MFN 06-257

Docket No. 52-010

**Subject: Response to Portion of NRC Request for Additional Information  
Letter No. 40 Related to ESBWR Design Certification Application –  
ESBWR Probabilistic Risk Assessment – RAI Numbers 19.1-8,  
19.1-17, 19.2-6, 19.2-10, 19.2-13 and 19.2-18**

Response to Portion of NRC Request for  
Additional Information Letter No. 40  
Related to ESBWR Design Certification Application  
ESBWR Probabilistic Risk Assessment  
RAI Numbers 19.1-8, 19.1-17, 19.2-6, 19.2-10,  
19.2-13 and 19.2-18

Figure 6.2-28. Vacuum Breaker Design Features

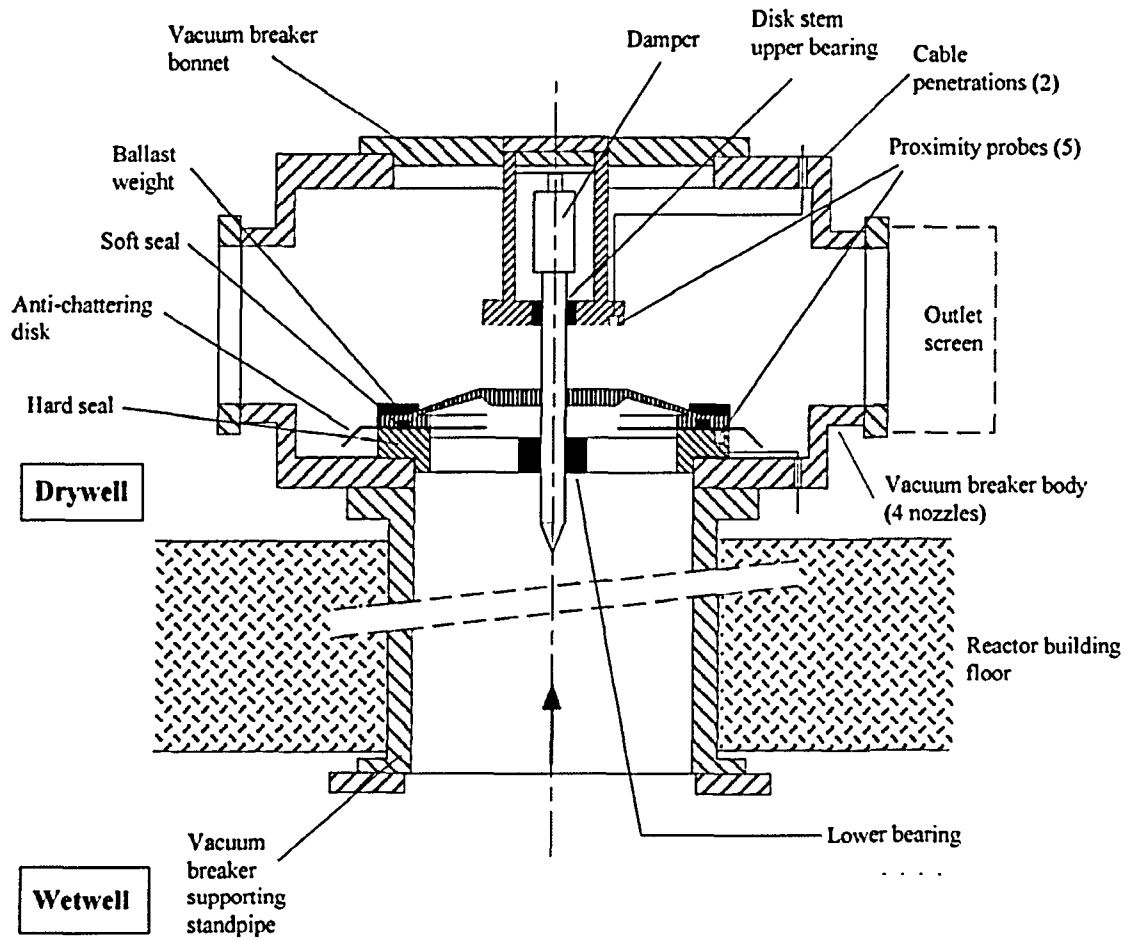
*Provide additional information regarding the drywell to suppression chamber vacuum breakers, including drawings showing the vacuum breaker, proximity/position sensors, and DC motor-operated valve that would provide isolation if the vacuum breaker sticks open or leaks in its closed position (as described in Section 4.18.3.1 of the PRA).*

DCD Section 6.2.1.1.2, fifth paragraph under the heading “Drywell” provides description of the drywell-to wetwell vacuum breaker and the upstream isolation valve. This paragraph will be revised to read as follows:

“Vacuum breakers are provided between the DW and WW. The vacuum breaker is self-actuating valve, similar to a check valve. The purpose of the DW-to-WW vacuum breaker system is to protect the integrity of the diaphragm floor slab and vent wall between the DW and the WW, and the DW structure and liner, and to prevent back-flooding of the suppression pool water into the DW. The vacuum breaker is provided with redundant proximity sensors to detect its closed position. On the upstream side of the vacuum breaker, a DC solenoid operated butterfly-isolation valve designed to fail-close is provided. The vacuum breaker is illustrated in Figure 6.2-28. During a LOCA, when the vacuum breaker opens and allows the flow of gas from WW to DW to equalize the DW and WW pressure and subsequently does not completely close as detected by the proximity sensors, a control signal will close the upstream butterfly-isolation valve to prevent extra bypass leakage due to the opening created by the vacuum breaker and therefore maintain the pressure suppression capability of the containment. Redundant vacuum breaker systems are provided to protect against a single failure of vacuum breaker, i.e., failure to open or failure to close when required. The design DW-to-WW pressure difference and the vacuum breaker full open differential pressure is given in Table 6.2-1.”

Figure 6.2-28 shown below will be added in DCD Tier 2.
